# Permitting decisions

## Variation including part refusal

We have decided to issue a variation for Milton Landfill Site operated by East Waste Limited. The permit number is EPR/BV4584IU/V011.

## Summary of proposals

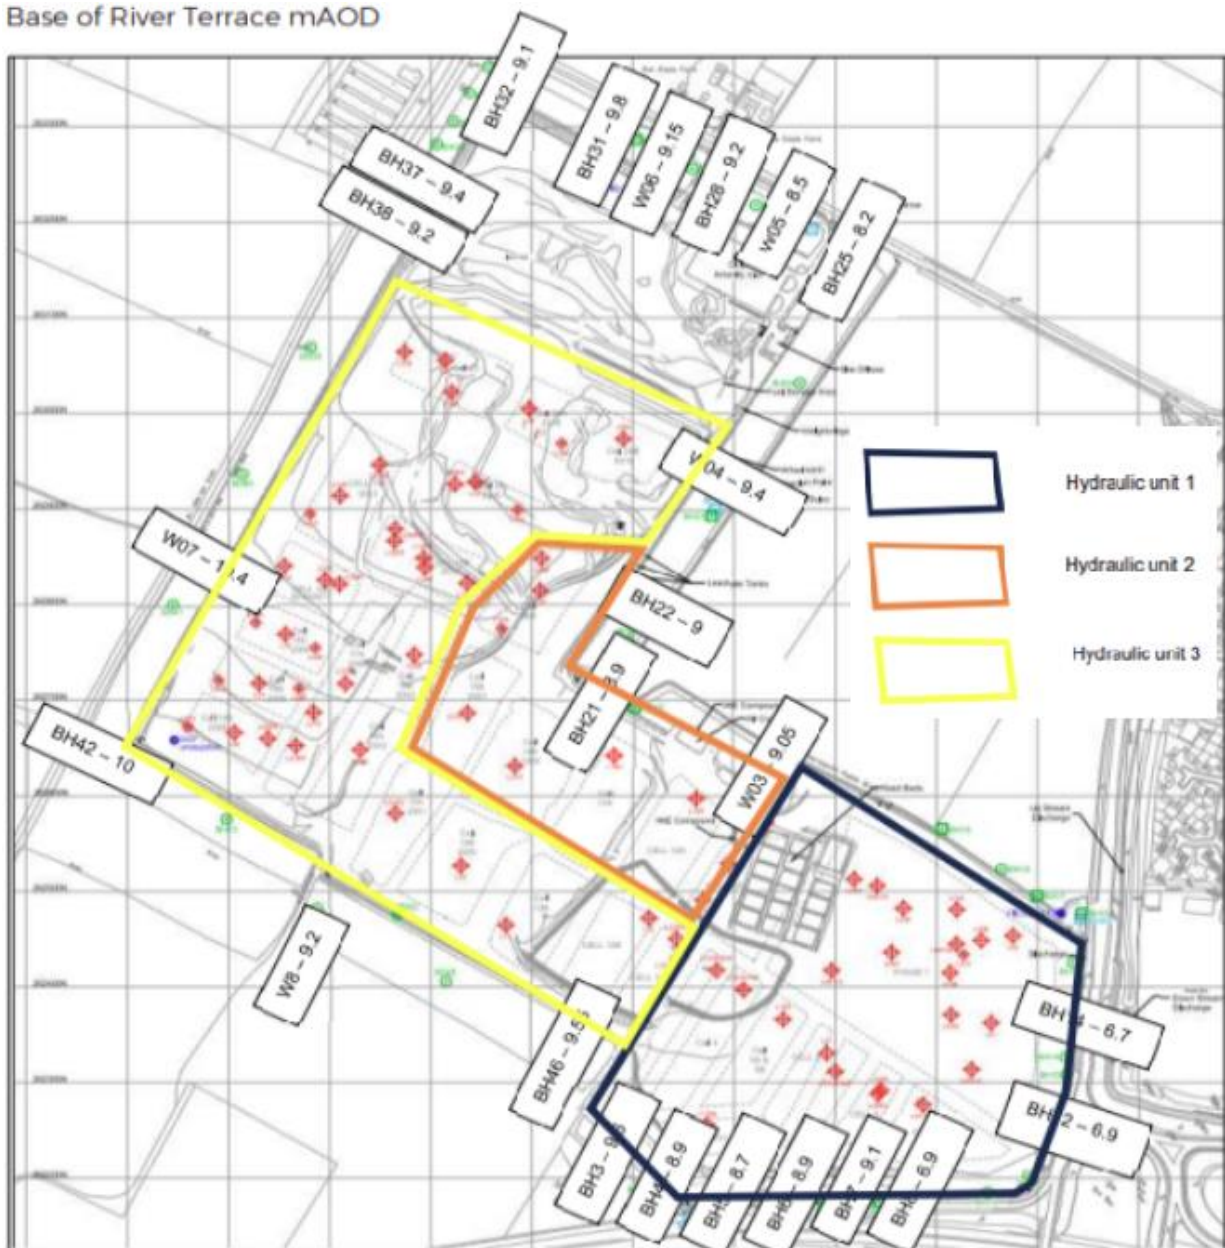
The proposal is to increase the level at which leachate is managed across the site to effectively generate three hydraulic phases (see map below provided with the Schedule 5 notice response and annotated with proposed compliance limits) where leachate would effectively lead to internal “channelling” of leachate towards the eastern area of the site (Phase I and part of Phase II). The levels proposed will lead to periods of time where there is advective leakage across the sidewall engineering into the RTD on the eastern boundary of the site. This is not an appropriate active control management proposal for cells designed to be hydraulically contained. It would be more appropriate to address leachate management proposals within an action plan designed to bring the site back into compliance with the hydraulic containment conceptual site model.

The variation application proposes three different leachate heads across three hydraulic units which are lowest in Hydraulic Unit 1 and highest in Hydraulic Unit 3. This will effectively create one large, connected phase that will cause leachate to flow towards cells that are the most vulnerable, hydrogeologically and for leachate management (Hydraulic Unit 1). No justification nor explanation of why this is appropriate has been provided, and no tailored leachate management plan has been proposed to explain how effective extraction will be achieved for Hydraulic Unit 1 where leachate will enter it from units 2 and 3.

Hydraulic unit 1, presented in the Schedule 5 response rather than the original application, proposes a leachate head of 8.0 m in Phase I and eastern areas of Phase II (Cells 1 and 9-11). This would overtop the base of the RTD by 1.3 m along the eastern boundary but provide a hydraulic containment freeboard of between 0.7 and 1.6 m elsewhere. Cross-section figures in the HRA show the average groundwater level rather than the lowest groundwater level. The 5<sup>th</sup> percentile groundwater level provided in the HRA for BH12 is 7.42 m AOD suggesting that this area of the site would be hydraulically contained if a lower leachate compliance limit of 7 m AOD were applied.

Hydraulic unit 2 proposes a revised head of 8.5m, which would provide 0.4m of freeboard capacity, against the base of the RTD in BH21. The freeboard offered by groundwater levels in the area has not been quantified. No assessment of the appropriate freeboard under hydraulic containment management is provided in the HRA.

Hydraulic unit 3 applies for a revised head of 9.0m, which would give a 0.2m capacity to the southern boundary of the Site, increasing in places to up to 1.4m. This gives a wide discrepancy across the area in the freeboard capacity. The level of appropriate freeboard capacity has not been assessed against the standard requirement of 1 m nor how this will be appropriately monitored.

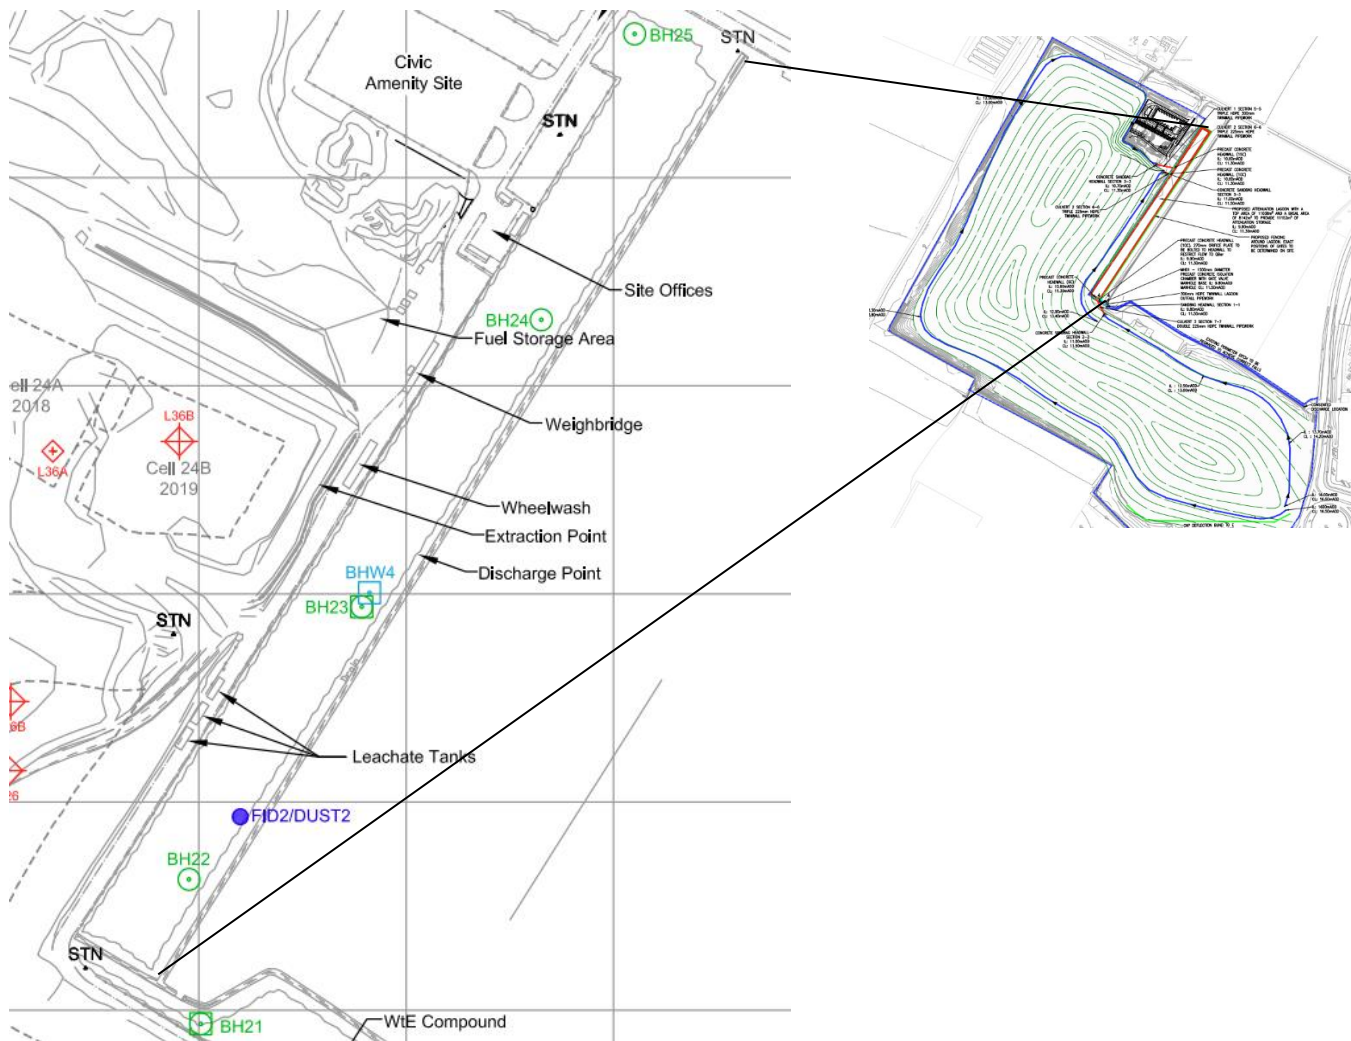
Drawing number WR7544/01/01 shows a flow direction for surface water around the perimeter of the site. Given that the topography appears to be at a steady 11.3 mAOD for most of the area in question, it is unclear what feature or process will encourage surface water flow as described.
